Pentium[®] II Processor Specification Update

Release Date: January 1999

Order Number: 243337-022

Figure 1. UP Dual Ended Termination (DET)

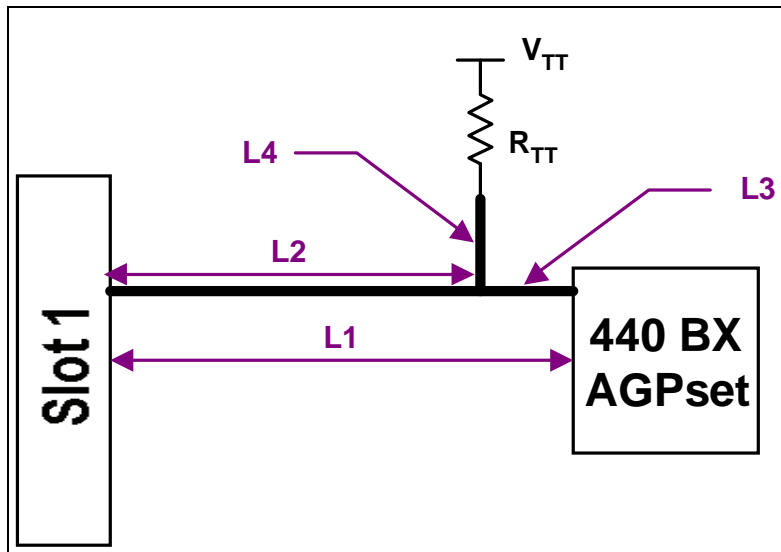
For UP-DET topologies (see Figure 1), the trace length L1 must be between 1.5" to 4.5" while using a 56Ω termination resistor.

Figure 2. DP Dual Ended Termination (DET)

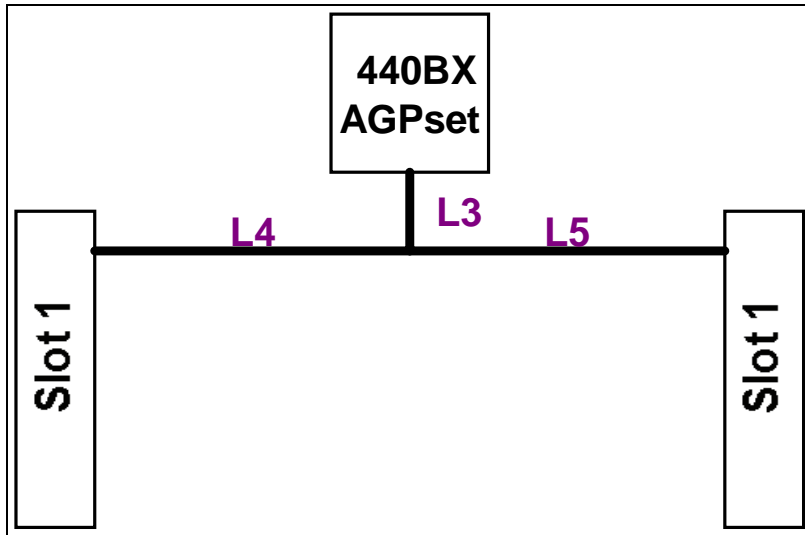
For DP topologies (see Figure 2) installed with a processor and a termination card, $L4 + L3$ or $L5 + L3$ must be less than or equal to 4.5". Additionally, for DP platforms with one processor installed, the termination card should be placed in the longer leg.

Figure 23. Processor with an Example Low Profile Heatsink Attached Using Spring Clips

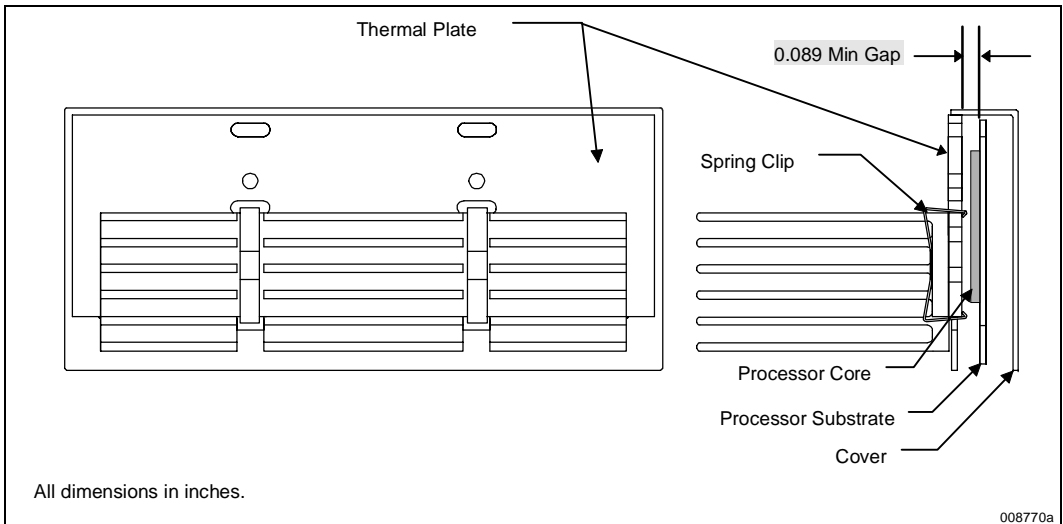
Figure 23 and Figure 24 illustrate example clip designs to support a low profile and a full height heatsink, respectively. The clips attach the heatsink by engaging with the underside of the thermal plate. The clearance of the thermal plate to the internal processor substrate is a minimum **0.089"** (illustrated in Figure 23 and Figure 24). The clips should be designed such that they will engage within this space, and also not damage the substrate upon insertion or removal. Finally, the clips should be able to retain the heatsink onto the thermal plate through a system level mechanical shock and vibration test. The clips should also apply a high enough force to spread the interface material for the spot size selected.

Figure 26. Heatsink Rivscrew* and Thermal Plate Recommendations and Guidelines

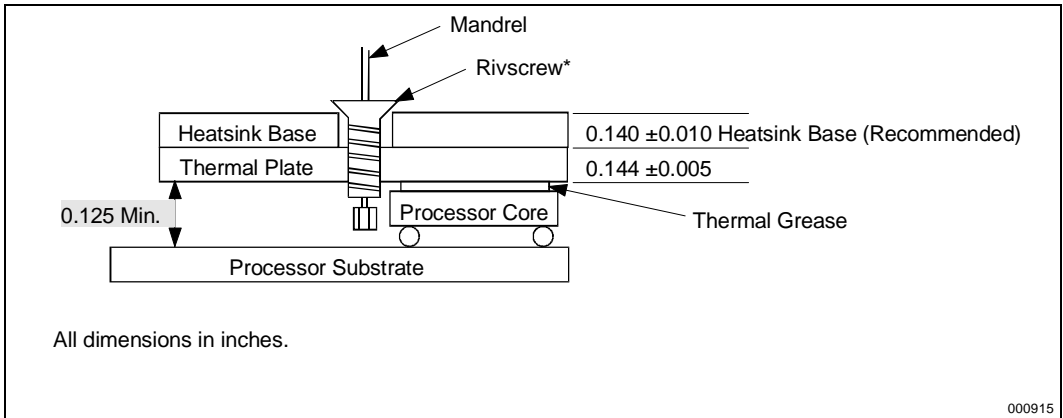
The Rivscrew attach mechanism uses a specialized rivet that is inserted through a hole in the heatsink into the thermal plate. Upon insertion, a threaded fastener is formed that can be removed if necessary. For Rivscrew attachment, the minimum gap between the thermal plate and the processor substrate is **0.125"**. For use of the Advel Rivscrew (part number 1712-3510), the heatsink base thickness must be $0.140 \pm 0.010"$. See Figure 25, Figure 26 and Figure 27 for details of heatsink requirements for use with Rivscrews.

Figure 6. BCLK to Core Logic Offset

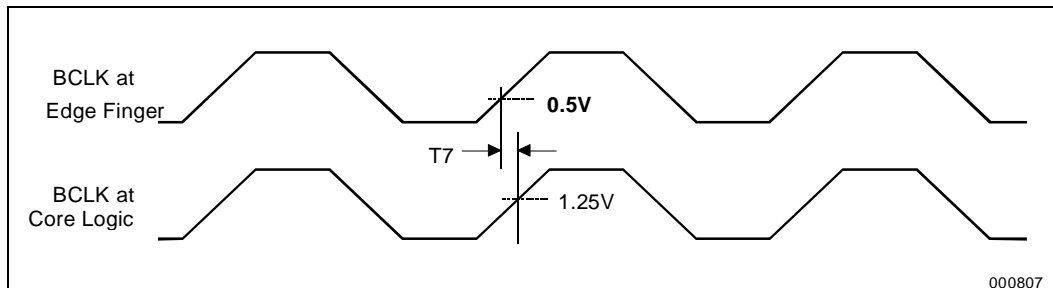
In Figure 6 of the *Pentium® II Processor at 233 MHz, 266 MHz, 300 MHz, and 333 MHz* datasheet, the following changes should be made:

Figure 7. BCLK*, PICCLK, and TCK Generic Clock Waveform

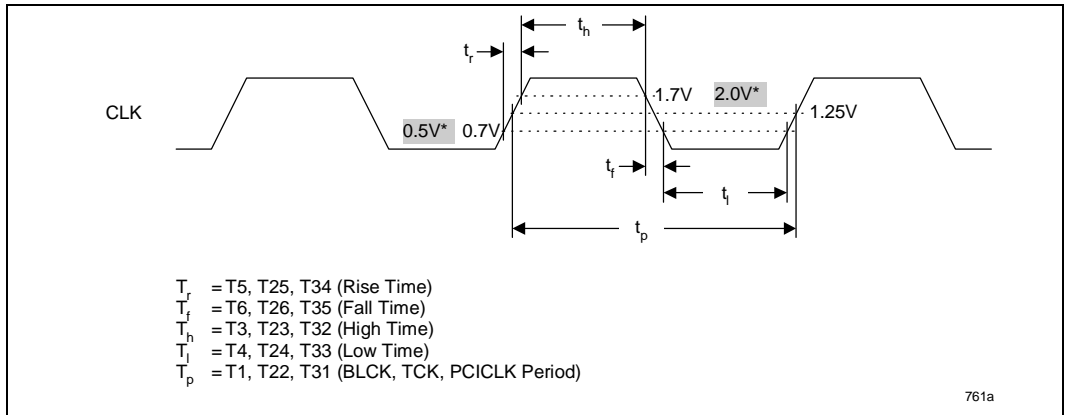
In Figure 7 of the *Pentium® II Processor at 233 MHz, 266 MHz, 300 MHz, and 333 MHz* datasheet, the following changes should be made:
